SCIT Report / Recommendations

10 AM September 11, 2024

Figure 1 North Taylor and East Essex Avenue

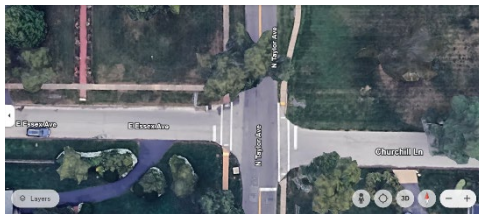
1. **E/W Crosswalks on: North Taylor at Longview and North Taylor and East Essex.** On July 24, 2024, Elizabeth Stickley (314-941-5656) requested crosswalks for children walking to and from Tillman Elementary.

- a. **Action:** No action will be taken at this time. Upon review, SCIT reviewed current accessibility and potential cost to make crossings ADA compliant and determined that the subject crossings will be considered when reconstruction of North Taylor takes place sometime in the future. There is a 4-way crossing at Quan and North Taylor that provides school access.
